ERRATA

PTI DC45.1-18

Recommendations for Stay Cable Design, Testing, and Installation

DC-45 Stay Cable Bridge Committee

Fig. C3.1 – Fatigue safety philosophy. (Note: Δ₁ is quality assurance [17 MPa coupled bar, 69 MPa strand and uncoupled bar, 103 MPa wire] and Δ₂ is length effect, anchorage riser, safety [35 MPa].)

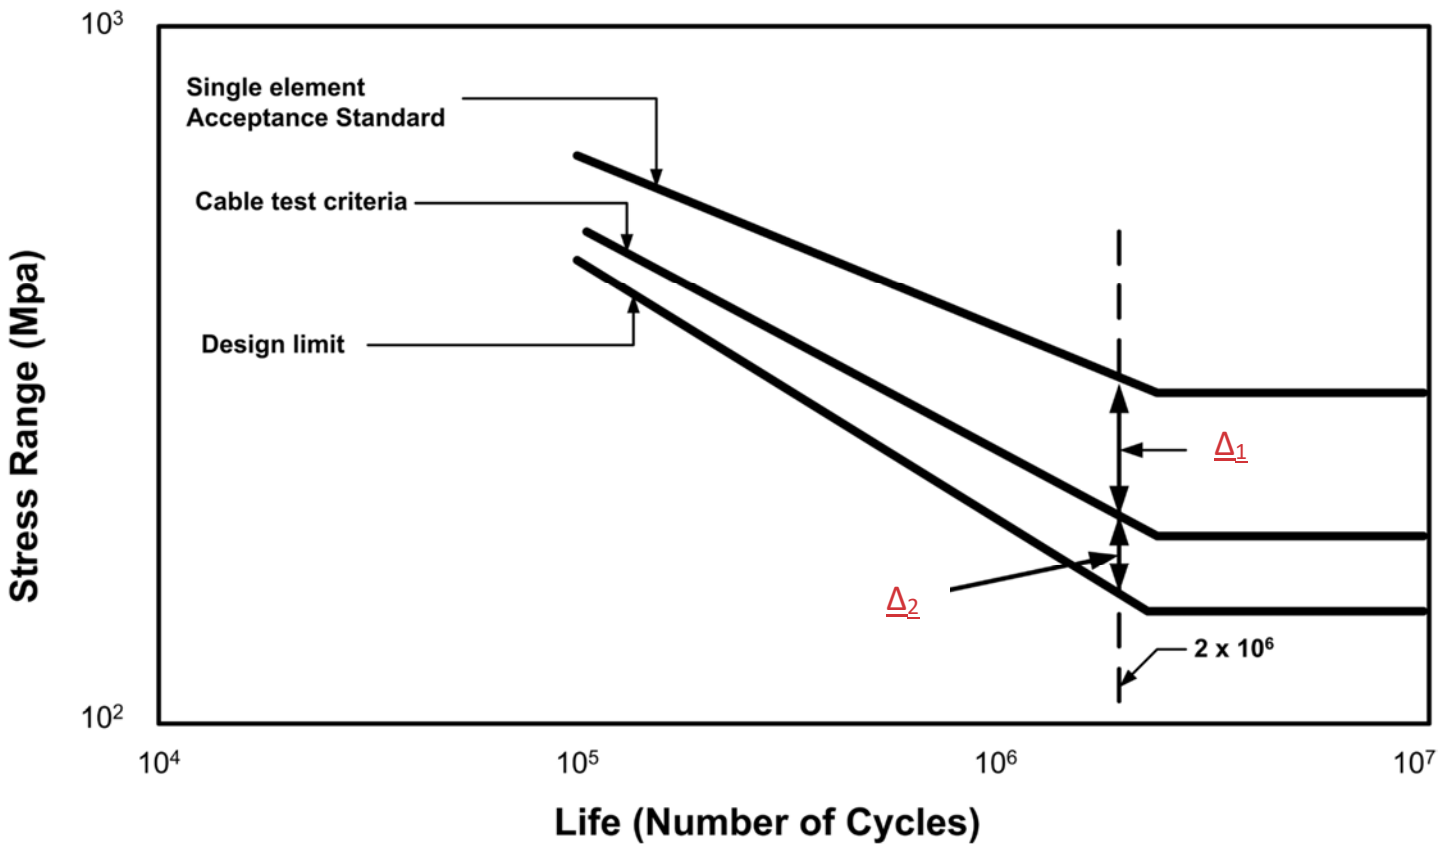
The following errata item was added on October 12, 2020:

Page 13, Fig. C3.1:
